**VOGTLE ELECTRIC GENERATING PLANT
RESPONSE TO REQUEST FOR ADDITIONAL INFORMATION -
REVISION 8 TO FIRST TEN-YEAR INTERVAL
INSERVICE INSPECTION PROGRAM**

**RESPONSE
TO
REQUEST FOR ADDITIONAL INFORMATION, RE:
REVISION 8 TO VOGTLE ELECTRIC GENERATING PLANT, UNIT 2,
FIRST TEN-YEAR INTERVAL INSERVICE INSPECTION PROGRAM**

FIGURE 1

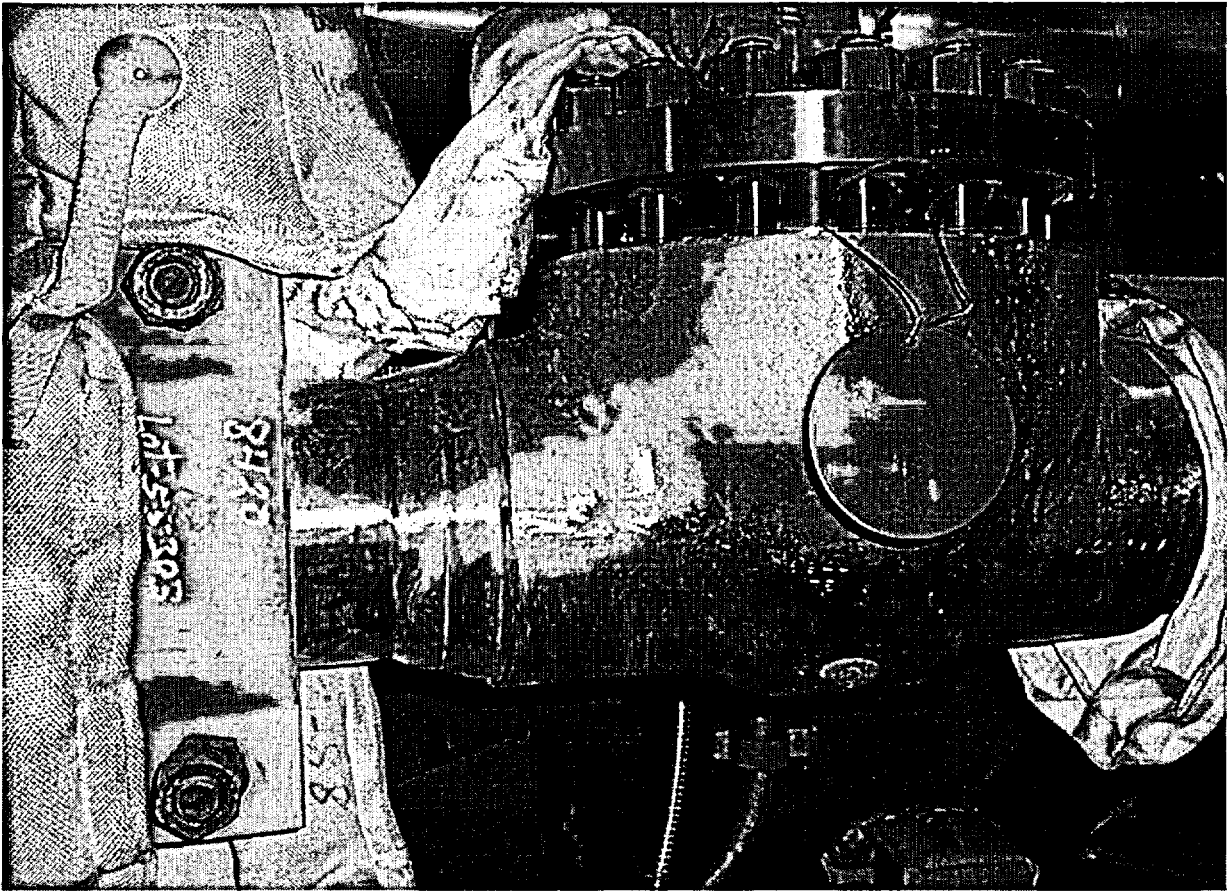
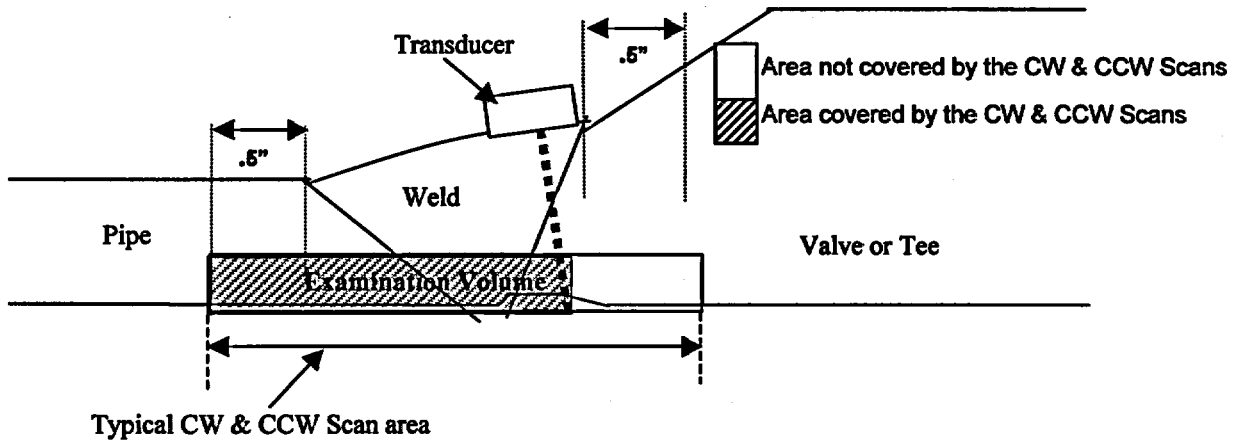
NRC REQUEST FOR ADDITIONAL INFORMATION 2.1:

"Request for Relief RR-20 (Revision 1) - The Code requires 100% volumetric and surface examinations of the welds identified in the licensee's submittal. The licensee stated that complete examination of these welds is limited by physical limitations due to geometric configuration. The table provided in the licensee's submittal provides minimal information on coverages achieved. Please provide (sic) specific description of geometrical constraints or interferences, (sic) and drawings or sketches showing the specific configurations of the subject welds to demonstrate the impracticality of meeting the Code examination requirements. This information is needed to support the determination that the subject Code requirements are impractical in accordance with 10 CFR 50.55a(g)(6)(i)."

The welds in Attachment 1 to Request for Relief RR-20 were added after the 2R6 outage, which was the first outage after updating to the 1989 Edition of the ASME Section XI Code from the 1983 Edition of the ASME Section XI Code. These welds are limited due to the additional requirement of Supplement 4 of Appendix III, referenced below.

Article III, Paragraph III-4430, of the 1989 Edition of ASME Section XI states, "The angle beam examination for reflectors transverse to the weld shall be performed on the weld crown on a single scan path to examine the weld root by one-half V path in two directions along the weld." This requirement is the same for the 1983 Edition of the ASME Section XI Code.

In addition to the above requirement, Supplement 4 (Austenitic and Dissimilar Metal Welds) of Appendix III was added to the 1989 Edition of ASME Section XI Code, which requires "The angle beam examination for reflectors transverse to the weld shall be performed in two directions covering the minimum area from 1/2 in. from one side of the weld crown to 1/2 in. from the other side of weld crown including the crown."

The Code coverages in question are Pipe to Valve and Pipe to Tee welds (see Attachment 1 to Request for Relief RR-20, Revision 8). These welds have configurations such that only scanning from the pipe side can be performed (up or down scans). For reflectors oriented parallel to the weld, 100% coverage can be obtained with this scan from the pipe side. No scans or coverages can be obtained from the Valve or Tee side. For reflectors oriented transverse to the weld (clockwise and counter-clockwise, i.e., cw and ccw, respectively), scanning can only be performed on the pipe side and the weld obtaining approximately 75% coverage. Please refer to Figure 1 that provides both a photograph and a diagram of the area of interest.

Typical Code coverage for scanning for transverse reflectors is normally around 75%; however, depending on the precise contour of the surface, more or less coverage may be obtained.

FIGURE 2

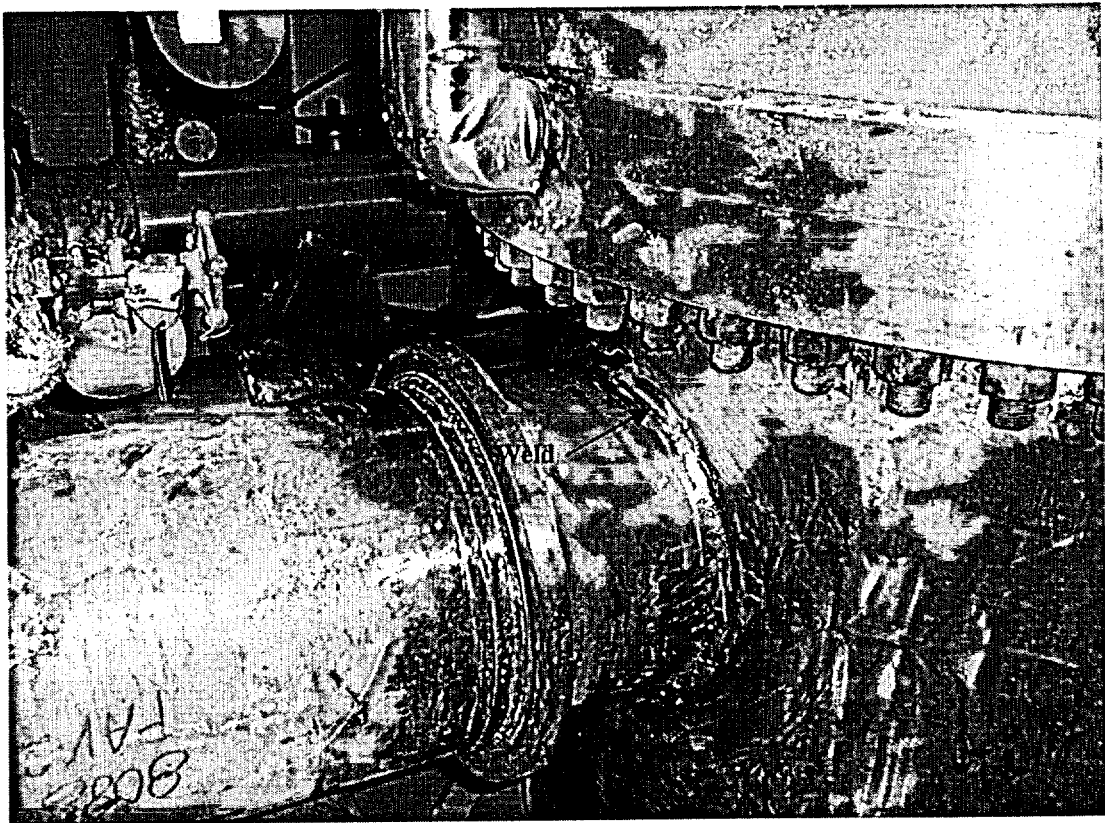
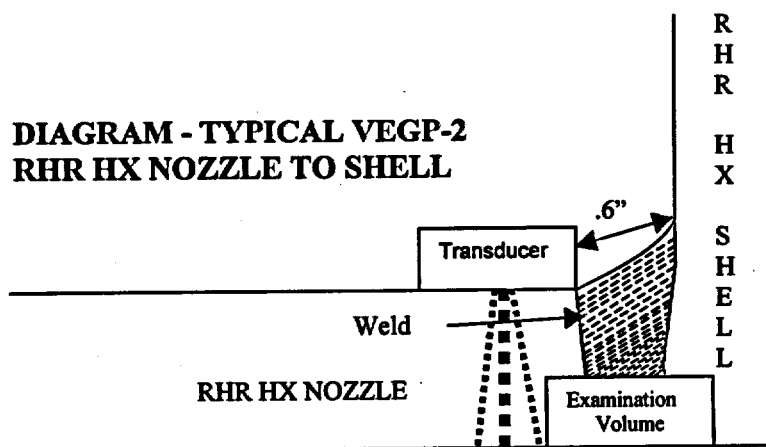
NRC REQUEST FOR ADDITIONAL INFORMATION 2.2:

"Request for Relief RR-30 (Part C-B) - The Code requires 100% volumetric and surface examinations of the welds identified in the licensee's submittal. The licensee stated that complete examination of these welds is limited by physical limitations due to component configuration. The table provided in the licensee's submittal provides minimal information on coverages achieved. Please provide (sic) specific description of geometrical constraints or interferences, (sic) and drawings or sketches showing the specific configurations of the subject welds to demonstrate the impracticality of meeting the Code examination coverage requirements. This information is needed to support the determination that the subject Code requirements are impractical in accordance with 10 CFR 50.55a(g)(6)(i). Additionally, it is unclear whether relief is for volumetric coverage, surface coverage, or both. Provide clarification detailing the specific examination coverages requiring relief."

Article I, Paragraph I-2200 of the 1989 Edition of ASME Section XI requires Vessel Welds less than or equal to 2 inches in thickness to be examined in accordance with Appendix III. Appendix III, Article III, Paragraph III-4430 states, "The angle beam examination for reflectors transverse to the weld shall be performed on the weld crown on a single scan path to examine the weld root by one-half V path in two directions along the weld." In addition to this requirement, Supplement 4 of Appendix III (Austenitic and Dissimilar Metal Welds) states, "The angle beam examination for reflectors transverse to the weld shall be performed in two directions covering the minimum area from 1/2 in. from one side of the weld crown to 1/2 in. from the other side of the weld crown including the crown."

The Code examination coverage in question is the Inlet Nozzle to Tube Side Shell Welds (please refer to Table 1). Because of the configuration of these welds, the only scan that can be performed for reflectors parallel to these welds is up or down. For reflectors oriented parallel to the weld, 100% coverage can be obtained with this scan. For reflectors oriented transverse to the weld (clockwise and counter-clockwise, i.e., cw and ccw, respectively), no coverage can be obtained resulting in a total Code coverage of 50%. Please refer to Figure 2 that provides both a photograph and a diagram of the area of interest.

FIGURE 3

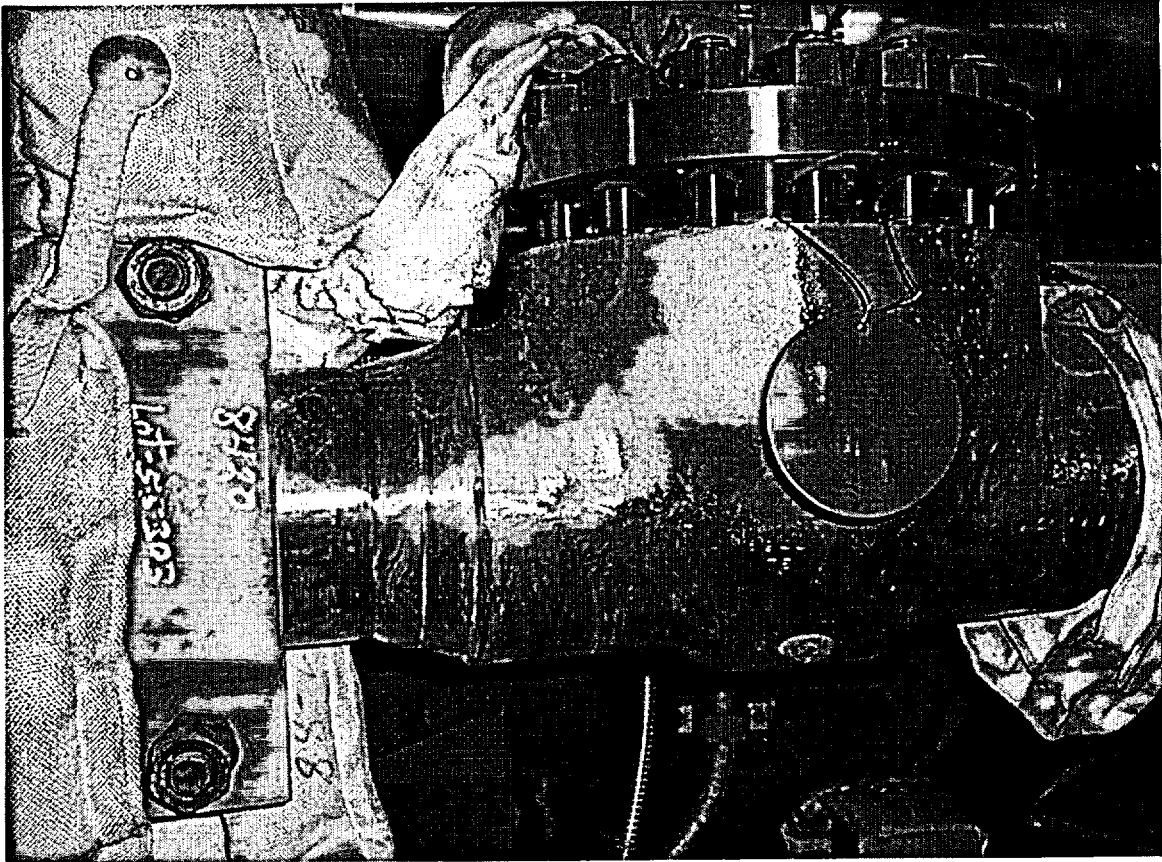
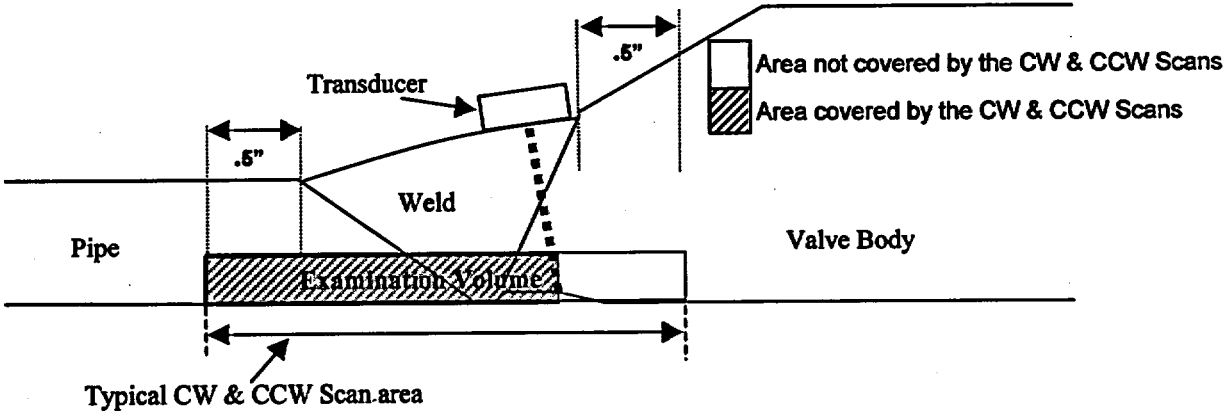
NRC REQUEST FOR ADDITIONAL INFORMATION 2.3:

"Request for Relief RR-34 (Part C-F-1) - The Code requires 100% volumetric and surface examinations of the welds identified in the licensee's submittal. The licensee stated that complete examination of these welds is limited by physical limitations due to geometric configuration, (sic) and component obstructions. The table provided in the licensee's submittal provides minimal information on coverages achieved. Please provide (sic) specific description of geometrical constraints or interferences, (sic) and drawings or sketches showing the specific configurations of the subject welds to demonstrate the impracticality of meeting the Code examination coverage requirements. This information is needed to support the determination that the subject Code requirements are impractical in accordance with 10 CFR 50.55a(g)(6)(i)."

The welds in Attachment 1 to Request for Relief RR-34, Revision 8, were added after the 2R6 outage, which was the first outage after updating to the 1989 Edition of ASME Section XI Code from the 1983 Edition of the ASME Section XI Code. These welds are limited due to the additional requirement of Supplement 4 of Appendix III, as referenced below.

Article III, Paragraph III-4430, of the 1989 Edition of ASME Section XI states, "The angle beam examination for reflectors transverse to the weld shall be performed on the weld crown on a single scan path to examine the weld root by one-half V path in two directions along the weld." This requirement is the same for the 1983 Edition of the ASME Section XI Code.

In addition to the above requirement, Supplement 4 (Austenitic and Dissimilar Metal Welds) of Appendix III was added to the 1989 Edition of ASME Section XI Code, which requires "The angle beam examination for reflectors transverse to the weld shall be performed in two directions covering the minimum area from 1/2 in. from one side of the weld crown to 1/2 in. from the other side of the weld crown including the crown."

The Code coverages in question are Pipe to Valve and Valve to Elbow welds (see Attachment 1 to Request for Relief RR-34, Revision 8). These welds have configurations such that only scanning from the pipe or elbow side can be performed (up or down scans). For reflectors oriented parallel to the weld, normally 100% coverage can be obtained, depending upon material type, with this scan from the pipe or elbow side. No scans or coverages can be obtained from the Valve side. For reflectors oriented transverse to the weld (clockwise and counter-clockwise scans, i.e., cw and ccw, respectively), scanning can only be performed on the pipe side and the weld obtaining approximately 75% coverage. Please refer to Figure 3 that provides both a photograph and a diagram of the area of interest. Typical Code coverage for scanning for transverse reflectors is normally around 75%; however, depending on the precise contour of the

surface, more or less coverage may be obtained.
